## SP AUSNET REVENUE RESET APPENDICES

### An independent review

<i>Document Reference:</i>	SPA2008Reset_Appendices_v5_0.doc
<i>Report Revision :</i>	5_0
<i>Report Status :</i>	Final
<i>Prepared by :</i>	
	<hr/>
	C Brennan, V Petrovski, J Thompson, M Walbank, P Walshe, P Williams
<i>Reviewed by :</i>	P Williams
	<hr/>
<i>Approved by :</i>	
	<hr/>
	P Williams
<i>Date Issued :</i>	16 August 2007

**Figure K-2 – Output of SPA's circuit breaker risk model for HWPS**

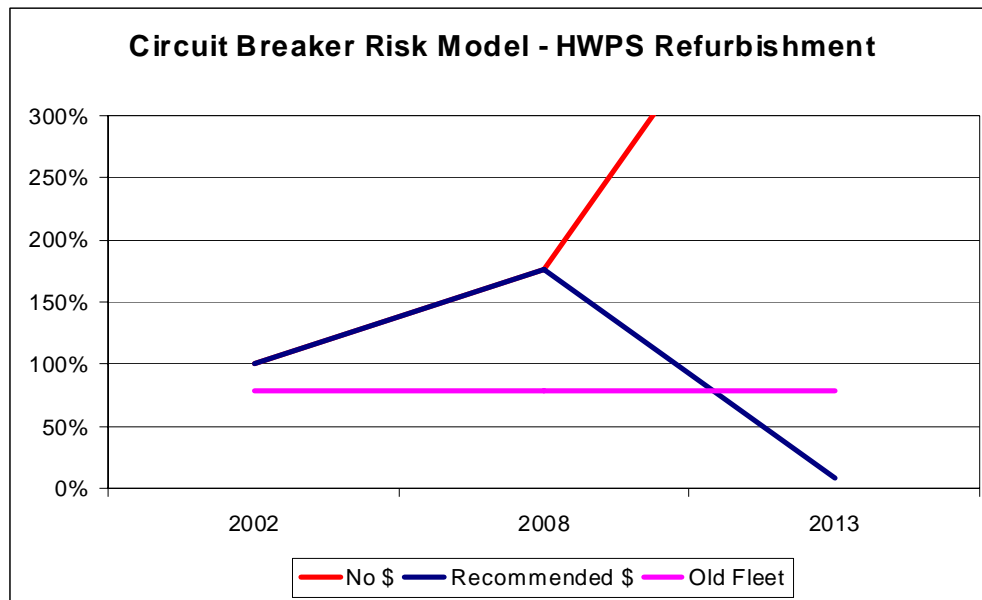
The key observations from Figure K-2 are as follows:

With respect to the system-wide (as opposed to station based) CB asset model risk (refer Figure 6-1), it is noted that replacement of the 24 JW420 CBs at HWPS prior to 2008 would reduce the relative risk level by 7.9%, and that replacement prior to 2013 would cause a relative reduction of 15.5%.

It is noted that joining the risk data points linearly gives the impression that the relationship between time and risk may be linear. PB understands that this is not necessarily the case and that, for example, the 'do-nothing' option does not result in a step change in rate of change of risk (with time) at 2008 – as may be inferred by the chart shown in Figure 0-6.

**Figure L-4 – Updated life expectancy of CTs proposed by SPA for replacement.**

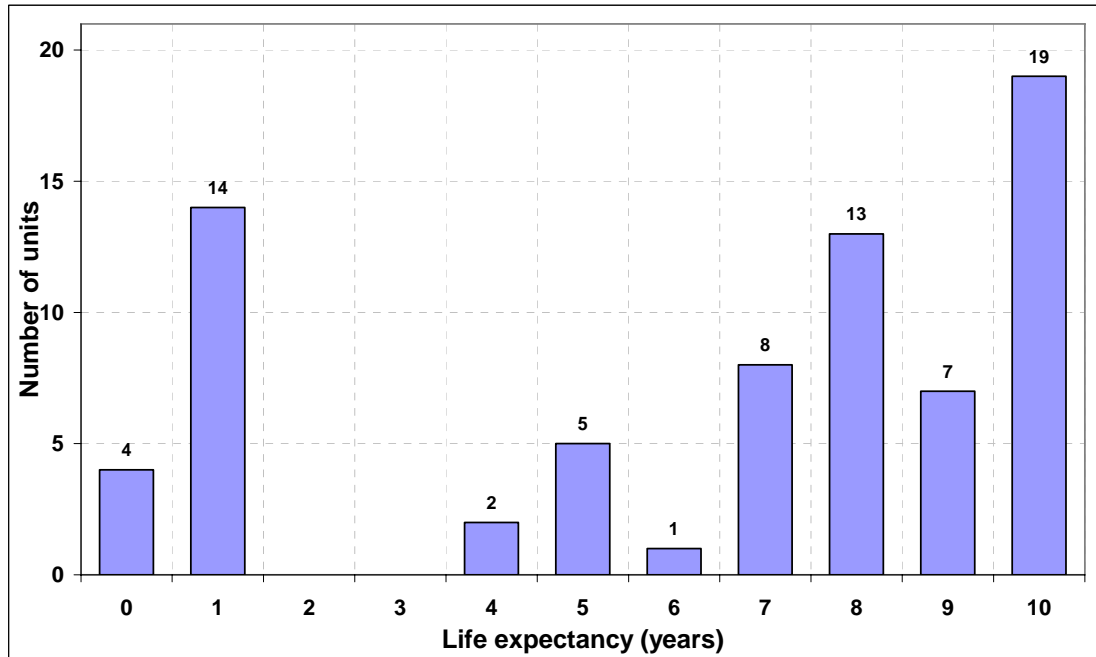
As part of discussions with SPA during our detailed review, PB raised some concerns regarding the apparent intentions to replace a number of CTs with high life expectancy (greater than 10 years) in the early stages of the 2008/09 to 2013/14 regulatory period. In particular, this was the case for an expensive set of 500 kV CTs at Loy Yang Power station switchyard (LYPS). SPA advised the original CT risk model outputs forming the basis of SPA’s revenue proposal, were prepared based on the information available at the time of the submission, which was October 2006. SPA advised that the life expectancy figures presented in Figure L-3 are based on the latest output of the CT risk model, as of May 2007 and therefore did not reflect its current CT replacement intentions. SPA explained the material change in CT life expectancy figures was due to the nature of the regular and ongoing condition monitoring of the CT assets, and that the outputs of its risk model are relatively volatile and dynamic. The life expectancy of CTs may be shortened and extended

substantially over a short period of time. SPA advised that in the case of the LYPS CTs, a previously identified problem was found to be less serious than envisaged. To offset this finding though, SPA also identified an issue regarding high dissolved gas levels with a fleet of 220 kV CTs subsequent to a post mortem examination of a failed unit at Terang (TGTS). Effectively the 18 CTs with a life expectancy of greater than 10 years in Figure L-3 are not currently planned for replacement; however as of May 2007 SPA has identified a similar number of CTs that have rapidly deteriorated so that their life expectancy has reduced to less than 10 years. This updated life expectancy of CTs proposed for replacement by SPA is shown in Figure L-4, which confirms that SPA is only preparing to replace CTs with a life expectancy of less than or equal to 10 years.

Given the dynamic nature of the CT risk model outputs, SPA has reinforced its position that the forecast capex on post-type CTs is very much an allowance only (in the context that the specific CT's nominated for replacement at this point in time may not be replaced) – since as time progresses the business will prioritise and manage its replacements based on the latest monitoring results, as required. In PB's view this is a sensible and practical approach.

Figure L-5 – Life expectancy of CTs recommended for replacement by PB.

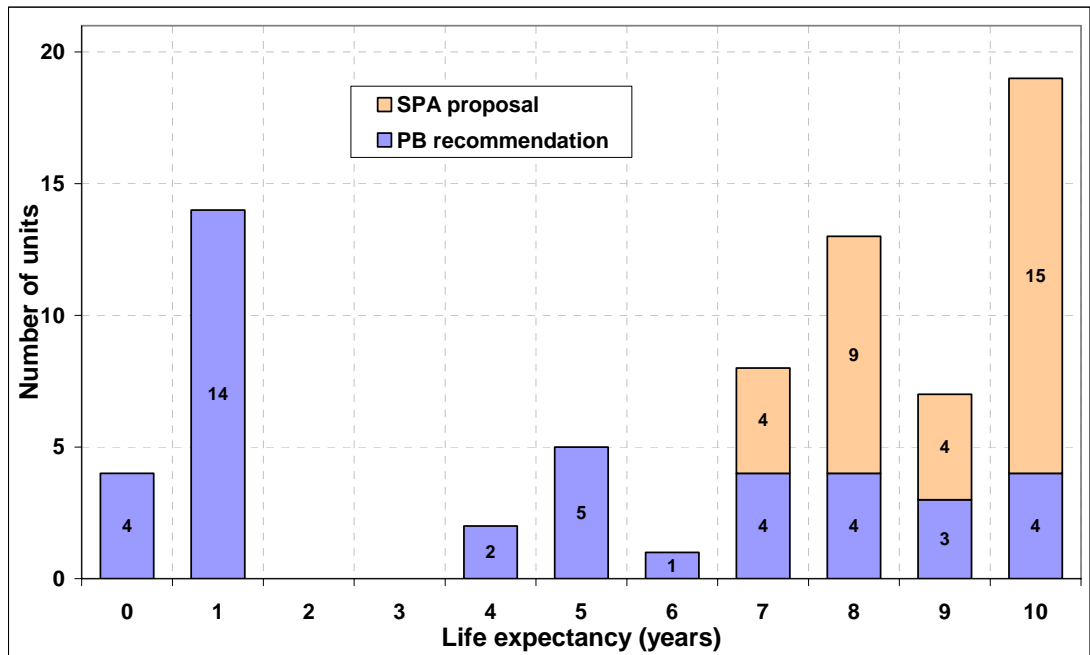
- a reduction in the total number of CT sets from 73 sets to 41 sets, as shown in Figure L-5
- minimal replacement of CTs that have a life expectancy greater than 7 years
- replacement of fifteen CTs with a life expectance of 7 years or greater - to capture economies of scale efficiencies
- single, critical CT replacements at Wodonga (WOTS) and Heywood (HYTS)
- wide scale replacements at Yallourn (x 16), Moorabool (x 10), Templestowe (x 8) and Fishbend (x 5)
- an allowance for the replacement of 1 x 220 kV, capacitor bank CT
- no replacements at Altona (ATS), Dederang (DDTS), Hazelwood Terminal (HWYS), Hazelwood Power (HWPS), Loy Yang (LYPS), Rowville (ROTS) South Morang (SMTS), Springvale (SVTS), Tyabb (TBTS), or West Melbourne (WMTS)
- a considerable reduction in the number of 500 kV CTs to be replaced
- a considerable reduction in the number of CVTs to be installed.

Figure N-1 – Output of SPA’s power transformer risk model.

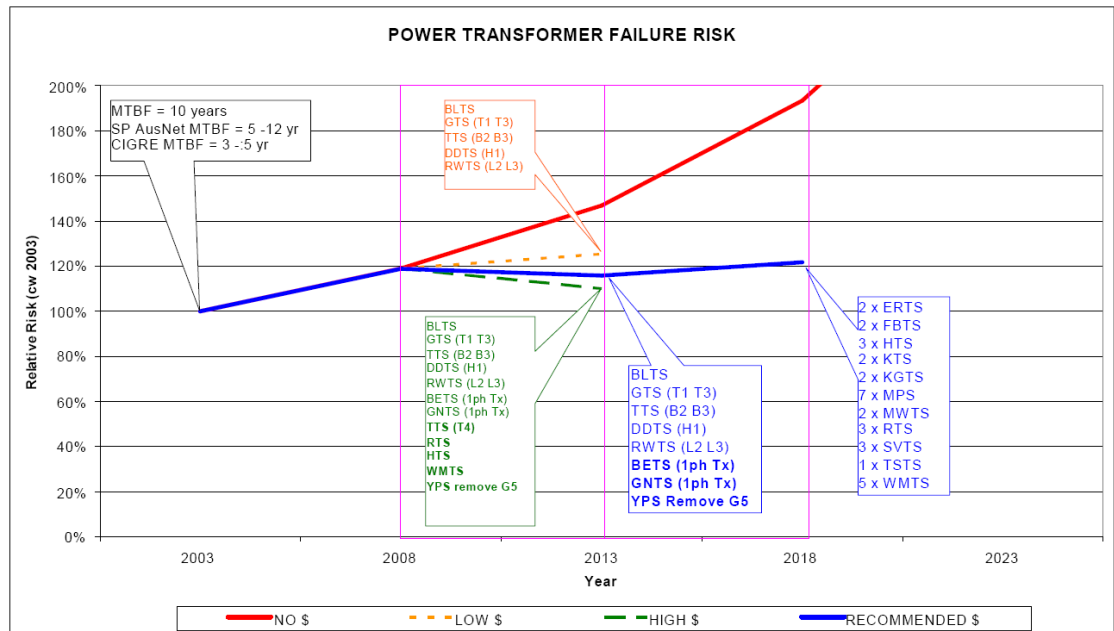
- With respect to the fleet of transformers, Figure N-1 indicates the incremental difference between the low expenditure (orange curve), the recommended expenditure (blue curve) and the high expenditure (green curve) is low and a need to extend the transformer replacements significantly beyond the station rebuilds is not clear. Notwithstanding this apparent lack of need, PB considers that as there are five 150 MVA transformers ranked at a position of 50 or higher in the asset risk model, sufficient need does exist to include an allowance based on one new unit as opposed to two. Such an allowance would also be consistent with SPA's proposal to re-develop West Melbourne towards the end of the regulatory period and further mitigate the risks of failure of critical metropolitan transformers. This outcome should also be considered in light of the availability of a spare metropolitan transformer and the release of units from Geelong<sup>161</sup>
